WATTS BAR 1&2  
(OL)  
50-390  
50-391

Re: Watts Bar Nuclear Plant  
NPDES No. TN0020168

Re: Watts Bar Nuclear Plant  
NPDES Permit No. TN0020168

We have reviewed the draft NPDES permit and Draft 316(a) Tentative Determination for the referenced facility, and have the following comments and requests.

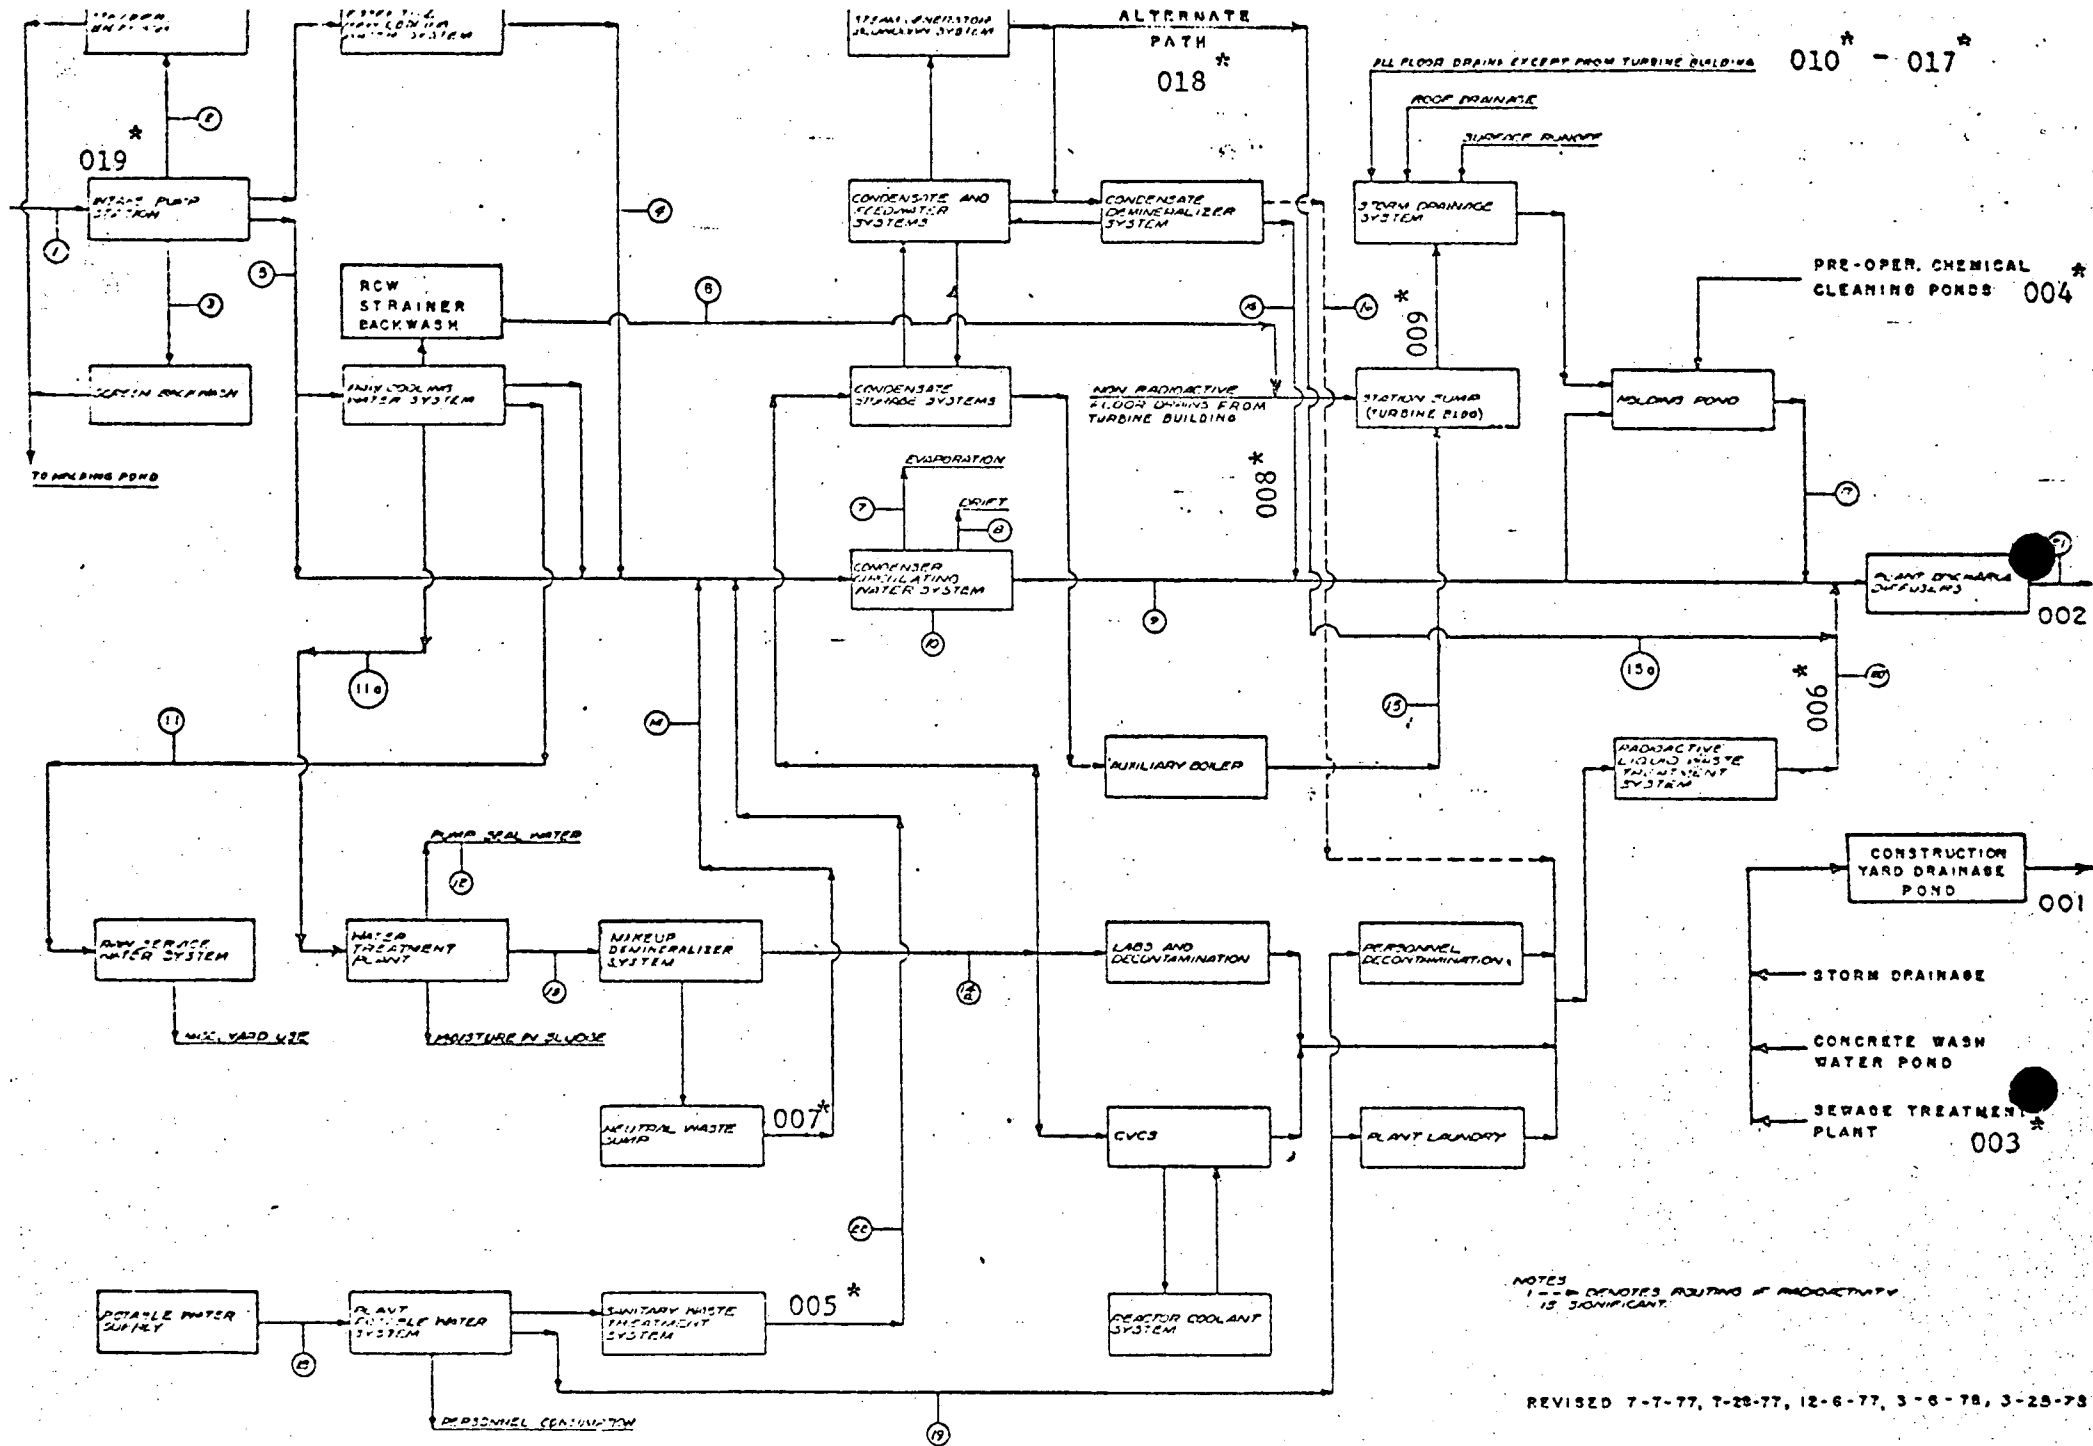
Pursuant to discussions with Mr. Charles H. Kaplan of your staff, we have enclosed two copies of a revised Water Use Diagram and supplemental thermal data which was developed in response to specific questions from Mr. Kaplan. Two copies of the Water Use Diagrams of reproduction quality were sent directly to Mr. Kaplan.
